Panel Report

Yarra Planning Scheme Amendment C220

Johnston Street Built Form Controls

22 February 2019

Figure 5: Affected VicRoads land

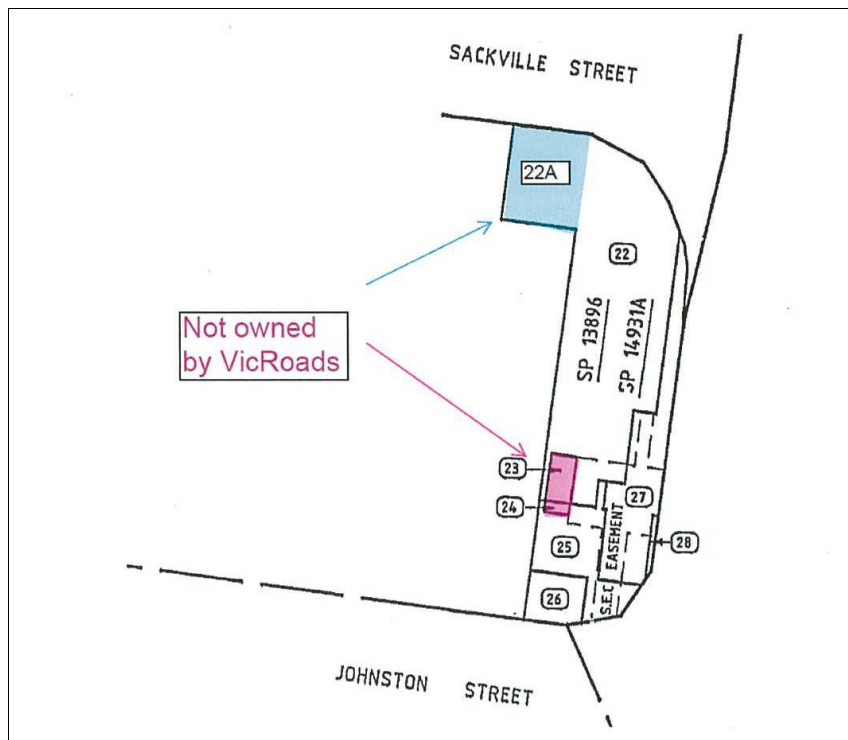
Having regard to the above, VicRoads in consultation with Transport for Victoria, CitiPower Pty and Powercor Australia Ltd requested the anomalies in the planning scheme map be corrected to:

- show the relevant parcels of land as a Road Zone Category 1
- correctly identify CitiPower's land as a Public Use Zone 1 or Public Use Zone 7.

After reviewing correspondence from VicRoads, Council advised⁴³ that it had revised its position in its Part C submission, which recommended that the land on the corner of Hoddle Street and Johnston Street should be included within a sub precinct and therefore subject to specific built form controls.

Rezone the VicRoads land on the northwest corner of Johnston Street and Hoddle Street, Collingwood to Road Zone Category 1 and delete Design and Development Overlay Schedule 15.

Rezone the CitiPower land near the northwest corner of Johnston Street and Hoddle Street, Collingwood to Public Use Zone (PUZ1) if compliant with the Ministerial Direction – *The Form and Content of Planning Schemes* and delete Design and Development Overlay Schedule 15.

Figure 7: Council Part B version preferred envelope

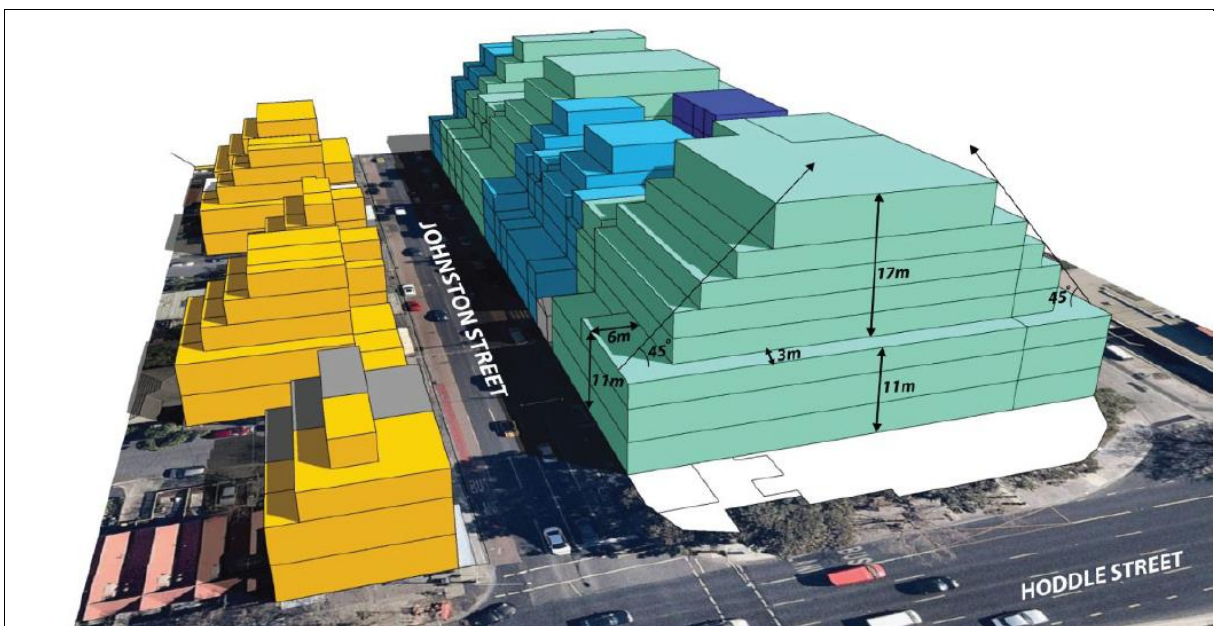
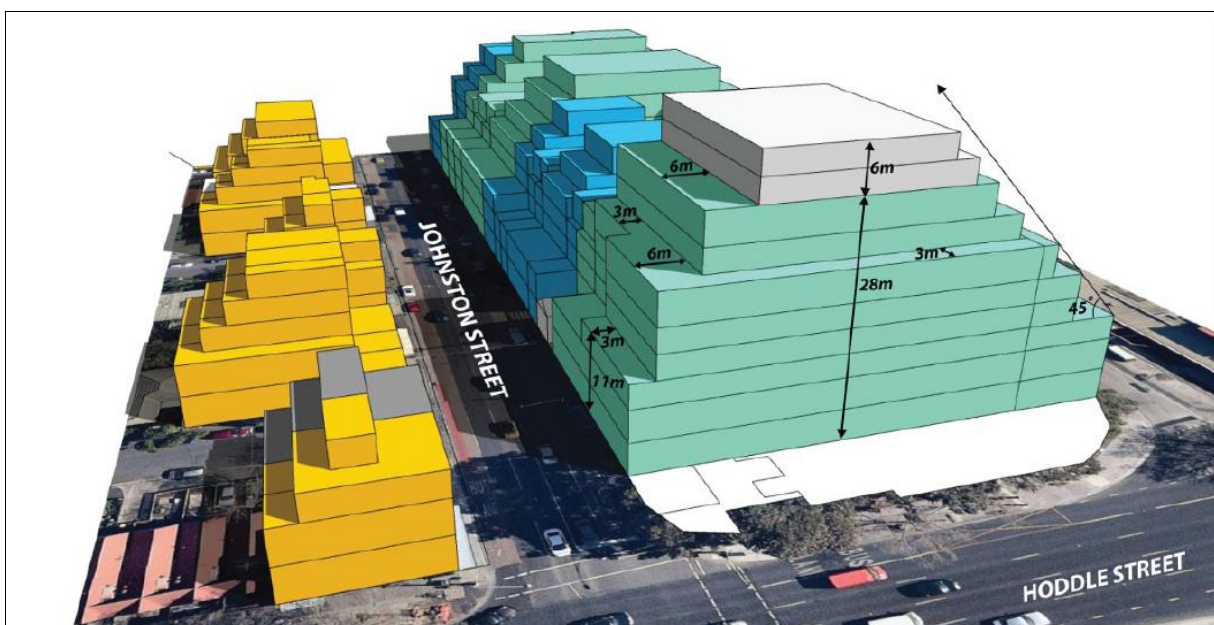
The built form controls proposed as part of the Amendment, both in the exhibited version and Council’s subsequent ‘preferred version’ – see Figure 7 – have a strong focus on matters of street wall height and upper level setbacks along Johnston Street as well as Sackville Street to the north. However, they have little to say about how a building form should be resolved on an important corner to a major arterial road.

The Aheron submission – see Figure 8 – sought:

- a stand-alone precinct
- an exemption from the (discretionary) 45 degree envelope
- discretion to allow the 6 metre setback above the street wall to reduce at the eastern end
- a greater preferred height (34 metres rather than 28 metres)
- to enable the site's 'gateway role' to be recognised.

Figure 1: Building envelope requirement

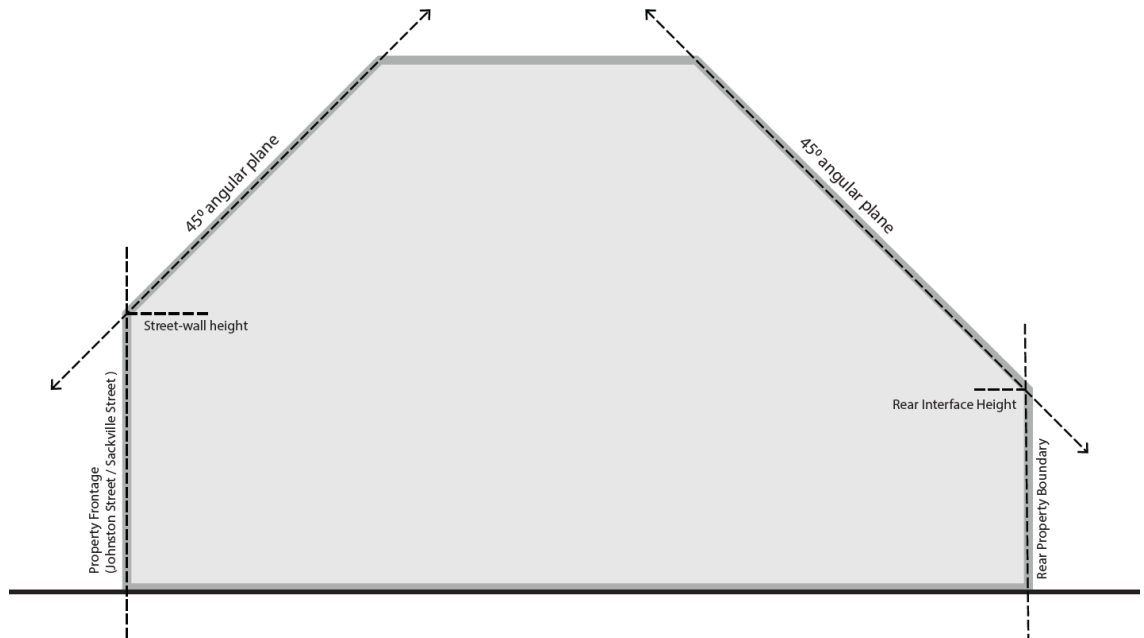
UPDATE DIAGRAM TO SHOW MID LEVEL SETBACKS ABOVE THE STREET WALL

New development on sites ~~with a north-south orientation~~ fronting Johnston Street, Sackville Street or Stafford Street, should be setback from the front and rear property boundary, ~~as illustrated in Figure 1 and~~ as specified in Table 45.
